Regional HOT Lanes Network Feasibility Study

PRELIMINARY ACCESS PLAN

Summary of Comments on Preliminary Access Plan, HOT Phase 3 Study

Figure 14: On- and Off-Ramp Volumes for SR-237 in Santa Clara County

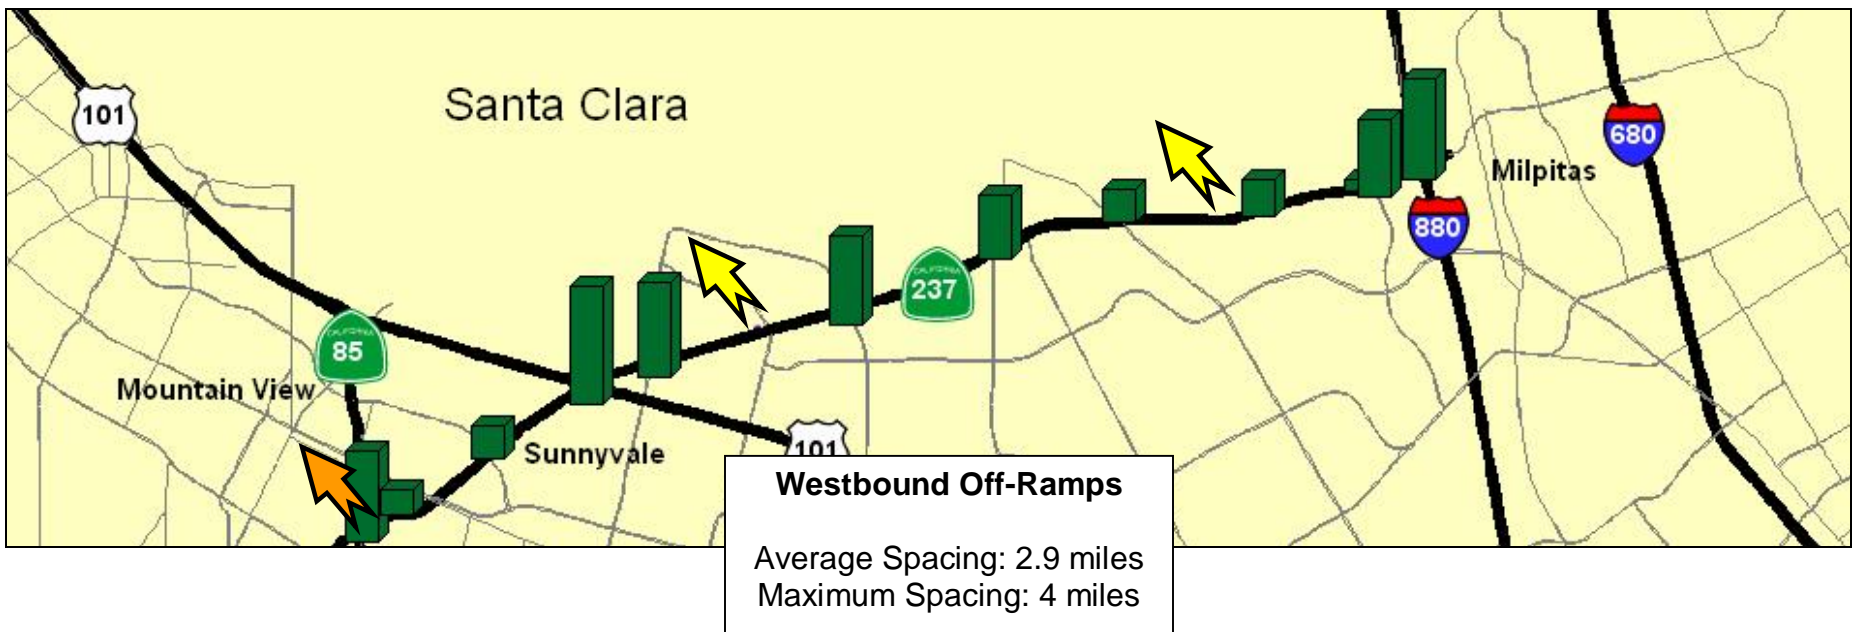
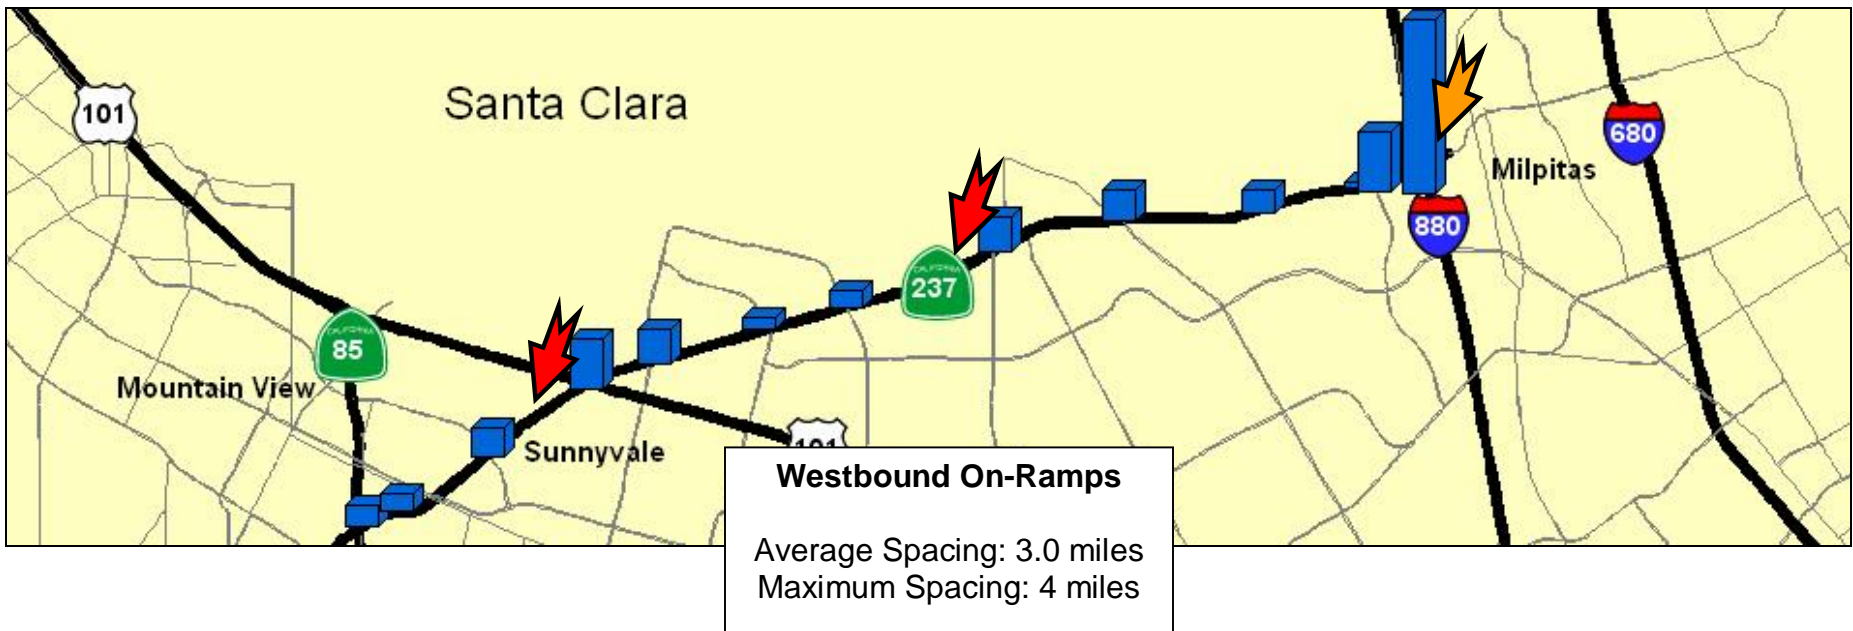
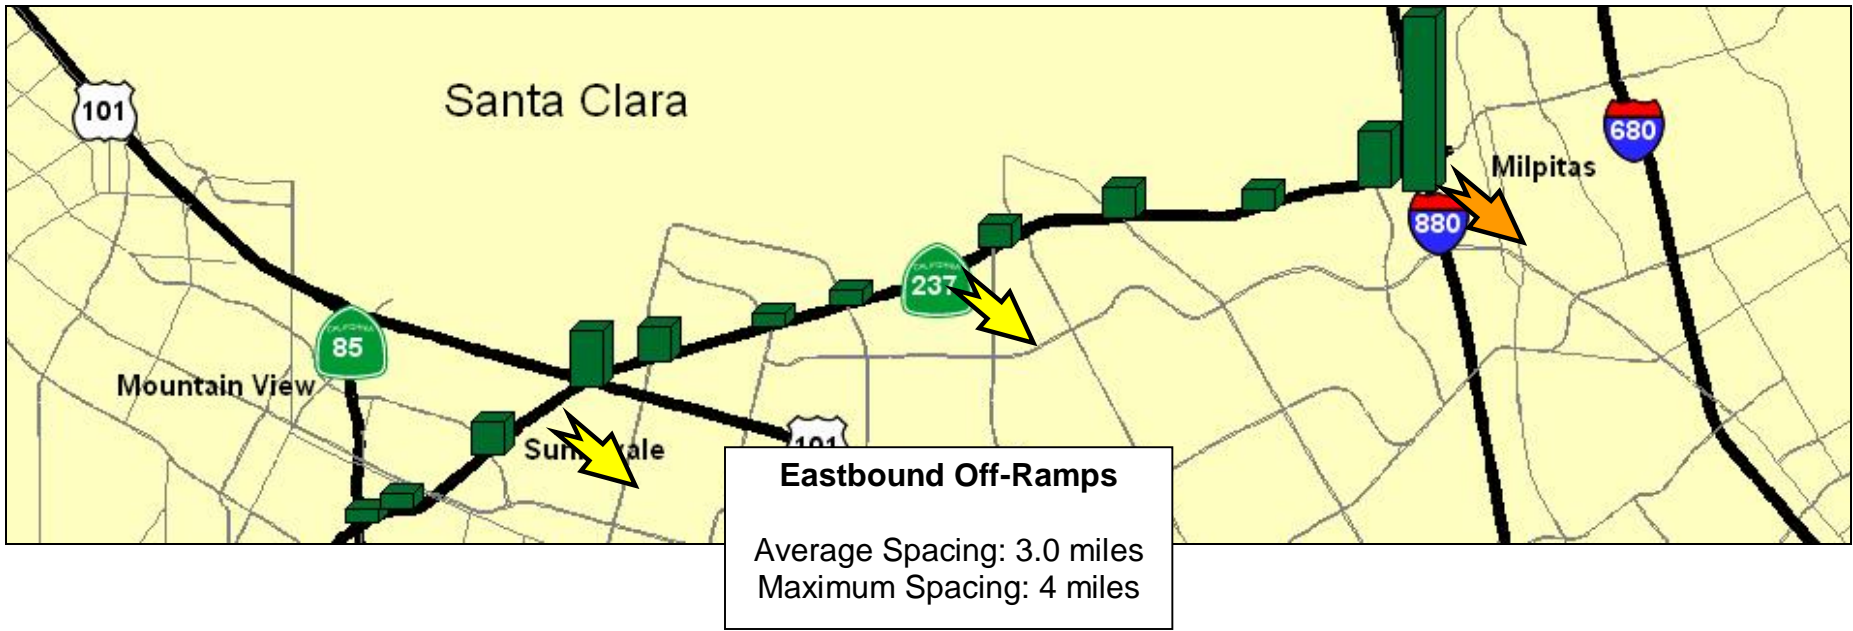
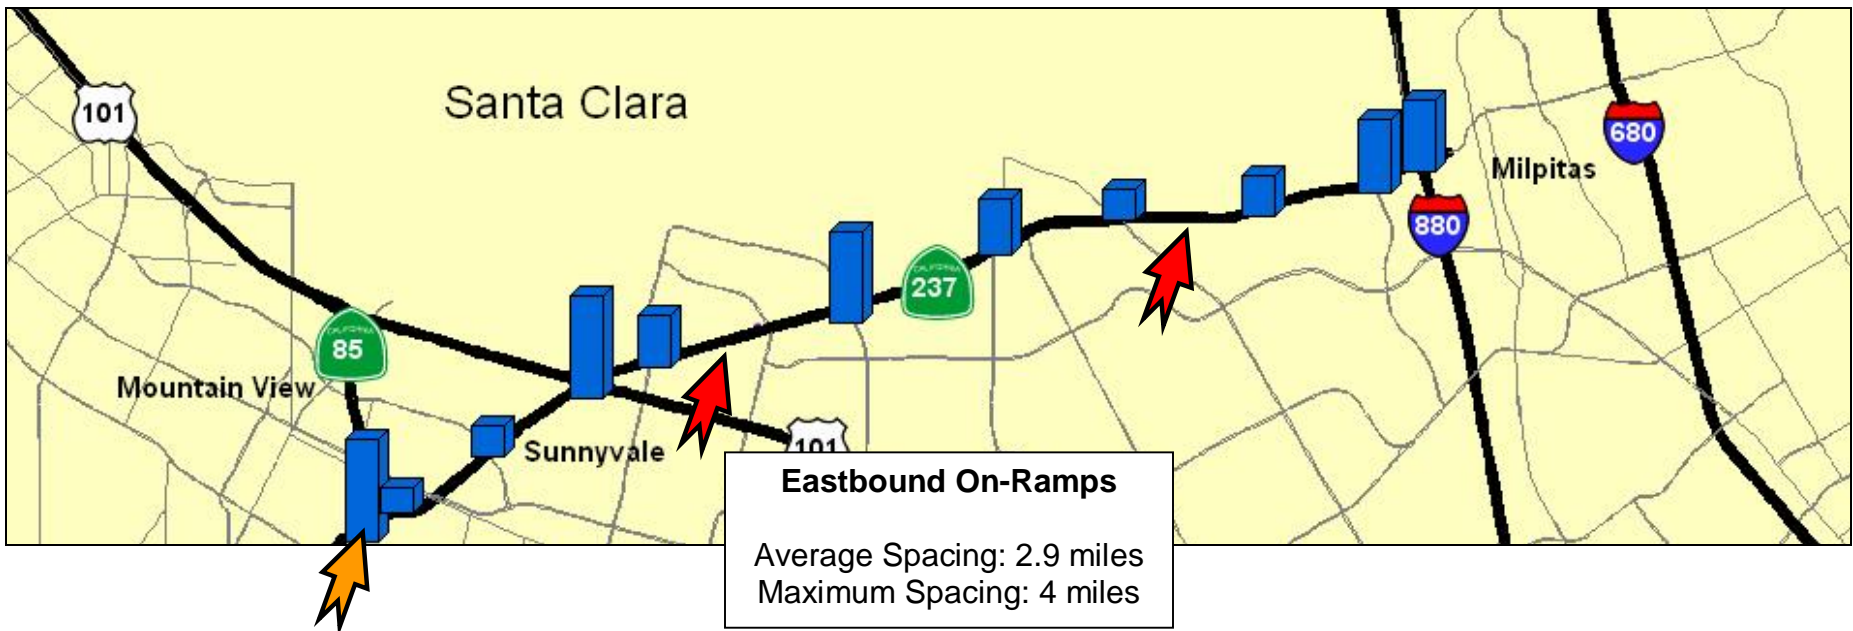
SCL-237 (MTC – subordinate to county/Ct comments)

- May not need EB off before 101. There is no interchange here and distance from start of HOT is relatively short.

SR 237/I-880 is a carpool-carpool direct connector location

EB On-Ramps

- add entry for SR 85, high volume from SR 85 to SR 237 to golden triangle area, major employment area, location for potential carpool-carpool direct connector in future
- 1st entry should capture US 101 and Mathilda Ave (can use the location where current carpool lane starts)
- add entry for Lawrence Expressway
- add entry for Great America (amusement park, future stadium for 49ers)
- ensure entry for Zanker Road, First Street combined

EB Off-Ramps

- add exit for Lawrence Expressway
- add exit for Great America (amusement park, future stadium for 49ers)
- don't know if exit for I-880 SB is needed, maybe back tracking, low volumes?

WB On-Ramps

- add entry for Lawrence Expressway
- add entry for Great America (amusement park, future stadium for 49ers)

WB Off-Ramps

- add exit for SR 85, high volume between SR 85 to SR 237 to golden triangle area, major employment area, location for potential carpool-carpool direct connector in future
- add exit for Lawrence Expressway
- add exit for Great America (amusement park, future stadium for 49ers)

Figure 15: On- and Off-Ramp Volumes for I-280 in Santa Clara County

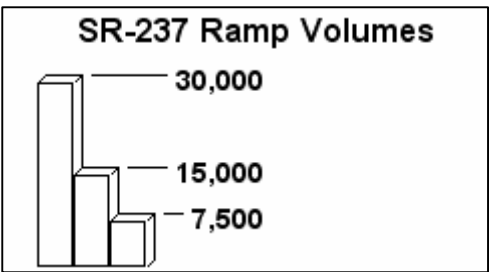
SCL-280 (MTC & Caltrans)

- May want NB on closer to 880/17 interchange (MTC – subordinate to county/Ct comments)
- Northbound I-280: There should be an ingress downstream of I-880/SR 17 interchange for vehicles coming from these routes. (Ct D4)
- Southbound I-280: There should be egresses just upstream of I-880/SR 17, SR 87 and US 101 interchanges for vehicles heading to these routes. (Ct D4)
- Southbound I-280: There should be an ingress just downstream of I-880/SR 17 interchange for vehicles coming from these routes. (Ct D4)

NB On-Ramps

- 1st entry for US 101 (ok), better closer to 24th Street/Mc Laughlin Ave., congestion near 10th Street
- 2nd entry for SR 87 appears to be close to I-880 where the existing carpool lane begins. This is also a location where there is congestion during PM peak. I would locate either an additional entry or relocate existing entry between Bird Ave. and Meridian Ave.
- There is potential to relocate 2nd entry further west or add an additional entry west of I-880.
- 3rd entry should be located between Saratoga Ave. and Lawrence Expressway
- Add entry to capture Lawrence Expressway (via Stevens Creek Boulevard) or relocate 3rd entry west of Stevens Creek Boulevard to capture San Tomas Expressway (via Saratoga Ave.), Saratoga Ave. and Lawrence Expressway
- 4th entry for SR 85 (ok)

NB Off-Ramps

- 1st exit to US 101 (ok)
- 2nd exit should provide for 11th/10th St. (San Jose State University) and SR 87
- 3rd exit for I-880/SR 17 ahead of the bottleneck near I-880Add exit for San Tomas Expressway/Saratoga Ave./Lawrence Expressway
- 4th exit for SR 85 (ok)

SB On-Ramps

- 1st entry for SR 85 (ok)
- Add entry for Lawrence Expressway? too close to Saratoga Ave?
- 2nd entry for Saratoga Ave. and San Tomas Expressway
- Add entry for I-880/SR 17
- 3rd entry for SR 87 (ok)
- Add entry for 10th Street/SJSU
- 4th entry for US 101 (ok)

SB Off-Ramps

- 1st exit for SR 85 (ok), consider distance for future ramp meter implementation at system interchanges
- have exit - either one or two to cater for Lawrence Expressway, Saratoga Avenue (San Tomas Expressway)
- add exit for I-880/SR 17
- add exit for SR 87
- add exit for US 101
